Access Compliance Report Public Rights-of-Way (Curb Ramps)

Main Street: CHANTICLEER_RD		Cross Street: S_GILBERT_ST		Location:	SE
ADA ID: RPAT220203095744	Ramp Type: Type 4 - Parallel	Initial Pass/Fail: Fail	Overall Compliance: No	Severity Score:	30

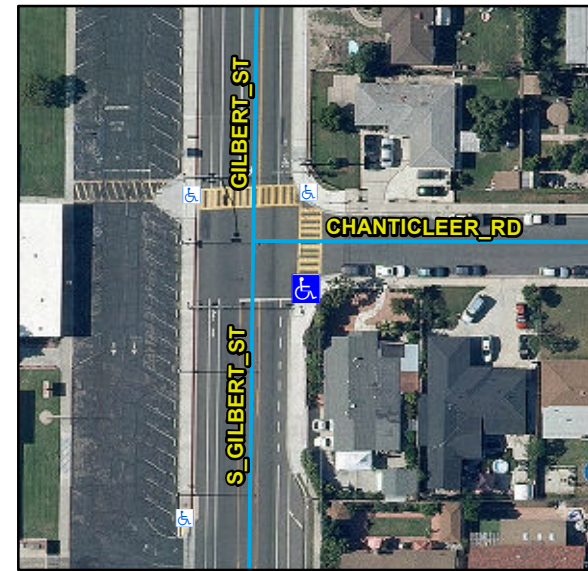
R304.5.3, STD 1115

Compliance	Description	Data	Compliance	Description	Data
N/A	Ramp Length LT (in)	104	N/A	Ramp Length RT (in)	116
Yes	Ramp Width LT (in)	71	Yes	Ramp Width RT (in)	70
Yes	Ramp Run Slope LT (%)	0.5	Yes	Ramp Run Slope RT (%)	0.3
No	Ramp Cross Slope LT (%)	7.1	No	Ramp Cross Slope RT (%)	7.4
N/A	Landing Present	N/A	N/A	DWS Provided	N/A
N/A	Landing Length (in)	N/A	N/A	DWS Contrast	N/A
N/A	Landing Width (in)	N/A	N/A	DWS Length (in)	N/A
N/A	Landing Run Slope (%)	N/A	N/A	DWS Full Width	N/A
N/A	Landing Cross Slope (%)	N/A		DWS Offset Type	N/A
N/A	Landing Movement Obstructed?	N/A	N/A	DWS Offset Left (in)	N/A
	Landing Movement Type	N/A	N/A	DWS Offset Right (in)	N/A
N/A	Landing Shared	N/A			
N/A	Clear Space	N/A			
N/A	Clear Space To Crosswalk (in)	N/A			
N/A	Marked Crosswalk 1	Yes	N/A	Marked Crosswalk 2	N/A
	Crossing 1 Direction	N		Crossing 2 Direction	N/A
	Marked Crosswalk 1 Width (in)	132		Marked Crosswalk 2 Width (in)	N/A

Remove & Replace Entire Ramp.
